FINAL
KENETECH/PacifiCorp
Windpower Project
Environmental Impact Statement

**FINAL ENVIRONMENTAL IMPACT STATEMENT
KENETECH/PACIFICORP WINDPOWER PROJECT
CARBON COUNTY, WYOMING**

This abbreviated FEIS revises and supplements the DEIS for this project. Public and agency comments on Chapters 1.0 through 4.0, 6.0 and 7.0, and Appendices A and B in the DEIS are incorporated into this document as errata. The DEIS will be required to accompany this FEIS because only the modifications, corrections, and additions are provided in the following material (with the exceptions of the Executive Summary, Section 3.2, part of Chapter 5.0, and Chapter 8.0). Section 3.2 of the DEIS is reproduced in its entirety because an additional 3.5 months of field data, which were not available at the time of the DEIS was prepared, were incorporated into the FEIS and because a substantial number of comments were received on this section. Chapter 5.0 was reorganized to define applicant-committed, project-wide, and resource-specific mitigation measures. All mitigations described in the DEIS and FEIS are recapitulated in Chapter 5.0 and summarized in Table 2.11 in the FEIS. Chapter 8.0 in the FEIS presents a summa

Figure 2.1 Flow Chart Showing Environmental Review Process and Agency and Public Consultation.

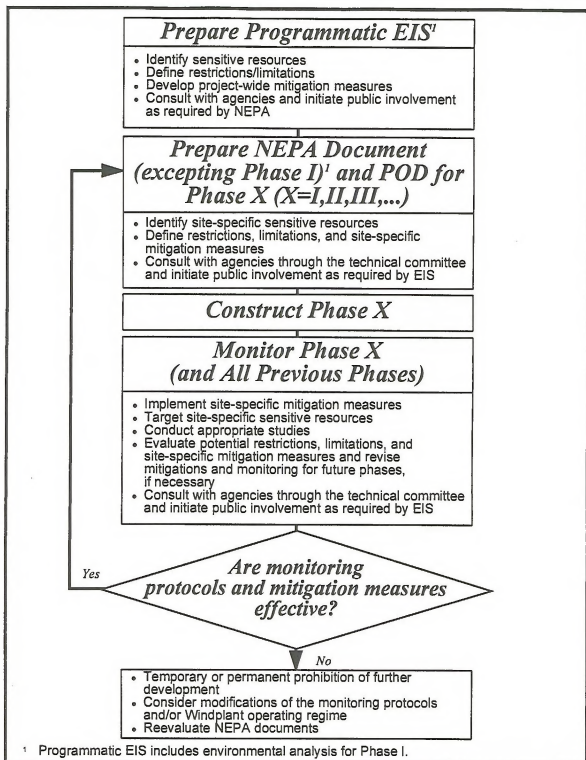
Page 2-7, Figure 2.1. Replace Figure 2.1 in the DEIS with Figure 2.1 in the FEIS.

Page 2-7, Figure 2.1. Any additional mitigation measures that might be required in PODs should be included as contingencies in the EIS along with meaningful criteria for monitoring effectiveness. Such criteria have not been provided for in the DEIS.

Map 2.1 Proposed Locations of Turbine Strings and Access Roads for the First Phase of Windplant Development on Foote Creek Rim.

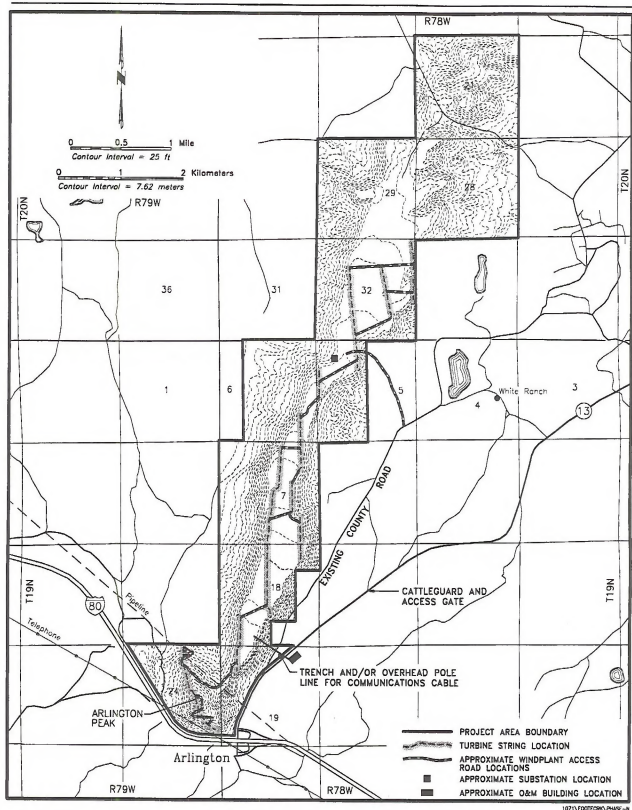
Page 2-6. Replace Map 2.1 in the DEIS with Map 2.1 in the FEIS.

Figure 2.2 Components of a Typical KVS-33 Windplant.

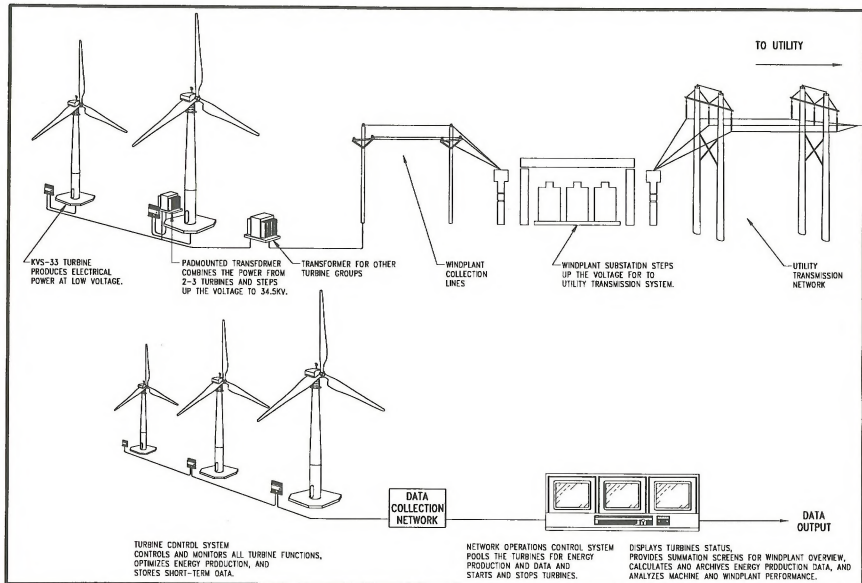
Page 2-9. Replace Figure 2.2 in the DEIS with Figure 2.2 in the FEIS.

Figure 2.3 Typical Site Plan of Turbine String Corridors and Roads.

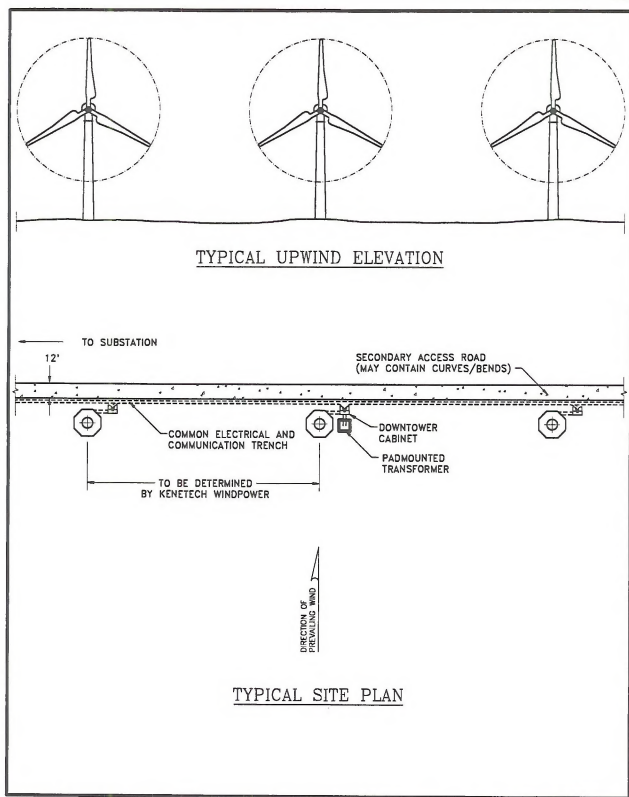
Page 2-10. Replace Figure 2.3 in the DEIS with Figure 2.3 in the FEIS.

Figure 2.4 Diagram of a Typical Tubular Tower-supported KVS-33 Wind Turbine Generator.

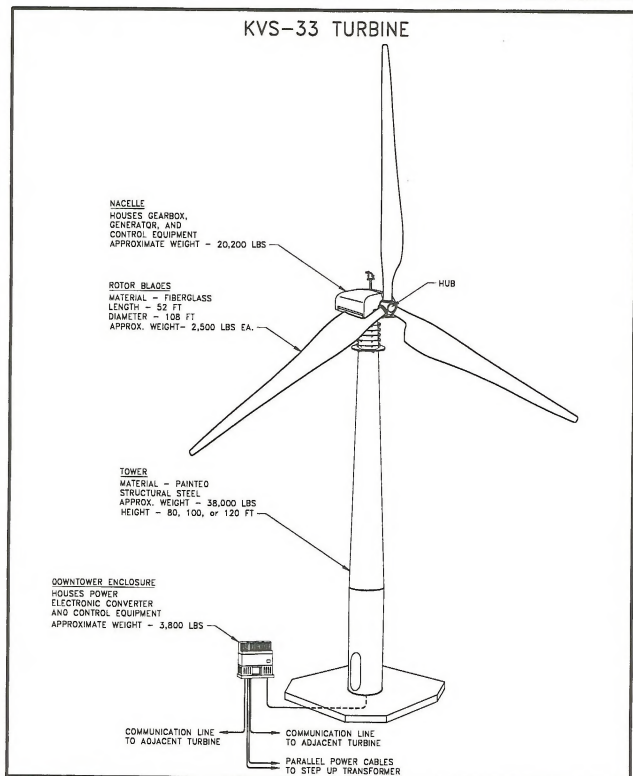
Page 2-12. Replace Figure 2.4 in the DEIS with Figure 2.4 in the FEIS.

Figure 3.2 Mean Number of Raptor Observations and Mean Number of Raptor Species Observed during Raptor Use (Continuous) and Passerine Surveys.

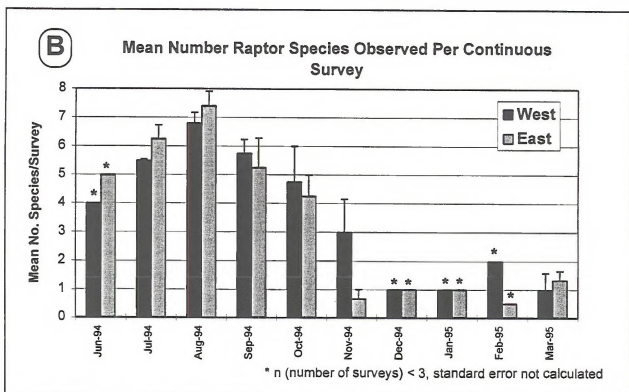
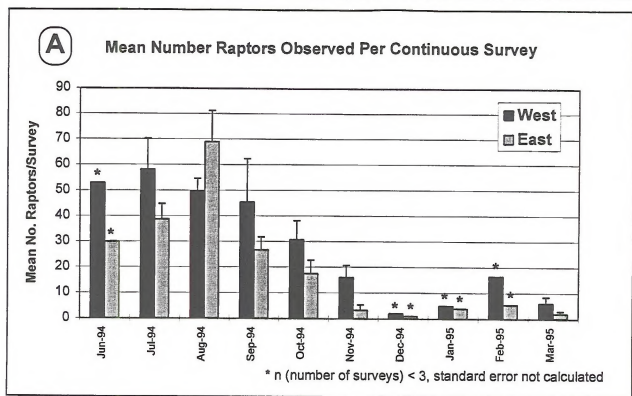
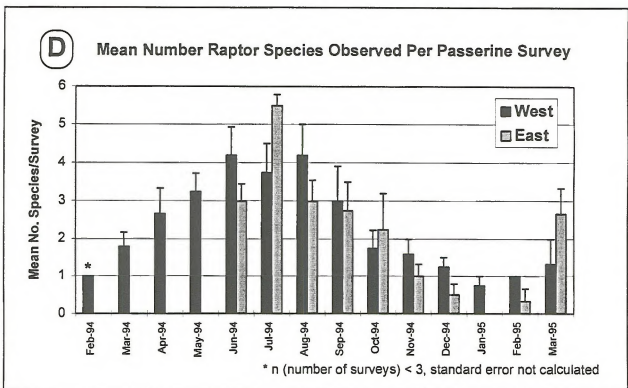
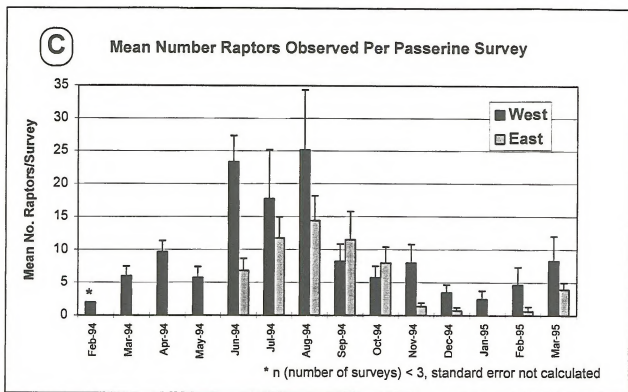
93 Page 3-48, Figure 2.11. It would be more meaningful if this figure included confidence intervals about site means versus observed peak monthly survey to help assess reliability of the data.

Comment AE74: Standard errors have been calculated and error bars have been added to the appropriate figures. Figures 3.2A and 3.2B in the DEIS were based on the total number of raptor species observed per month divided by the number of survey days for that month. These numbers have been recalculated by averaging the total number of species per survey by month to give a more representative overview of the data. This eliminates the tendency to underrepresent species which were commonly observed (i.e., golden eagle). See Figures 3.2 (A-D) and 3.3 (A-B) in Section 3.2 of the FEIS.

Comment AP93: Standard errors have been calculated and error bars have been added to the figures. Figures 3.2A and 3.2B in the DEIS were based on the total number of raptor species observed per month divided by the number of survey days for that month. These numbers have been recalculated by averaging the total number of species per survey by month to give a more representative overview of the data. This eliminates the tendency to underrepresent species which were commonly observed (i.e., golden eagle).

Figure 3.3 The (A) Mean Number of Passerine Species Observed Per Survey and (B) Mean Number of Passerine Observations Per Survey Along the West and East Sides of Foote Creek Rim, May 1994 to March 1995.

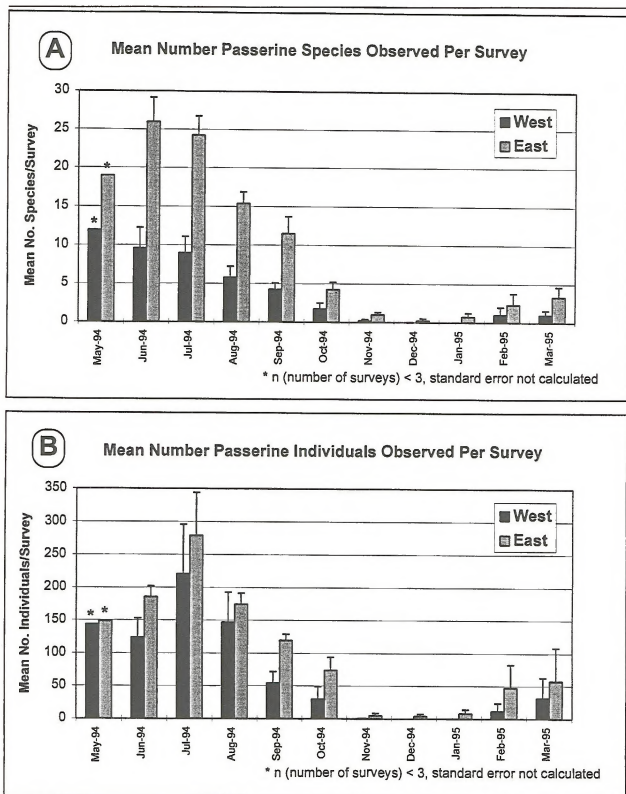
98 Page 3-61, Figure 3.1. Again, confidence intervals should be provided with the means on these figures to help readers assess the quality of the data presented.

Comment AE85: Standard errors have been calculated and error bars have been added to Figure 3.3 in the DEIS. Figure 3.3A in the DEIS (Section 3.2.2) was based on the total number of passerine species observed per month divided by the number of survey days for that month. These numbers have been recalculated by averaging the total number of species per survey by month to give a more representative overview of the data. This eliminates the tendency to underrepresent species which were commonly observed (i.e., horned lark). See Figure 3.3 (A-B) in Section 3.2 of the FEIS.

Comment AP98: Standard errors have been calculated and error bars have been added to Figure 3.3 in the DEIS. Figure 3.3A in the DEIS was based on the total number of passerine species observed per month divided by the number of survey days for that month. These numbers have been recalculated by averaging the total number of species per survey by month to give a more representative overview of the data. This eliminates the tendency to underrepresent species which were commonly observed (i.e., horned lark).
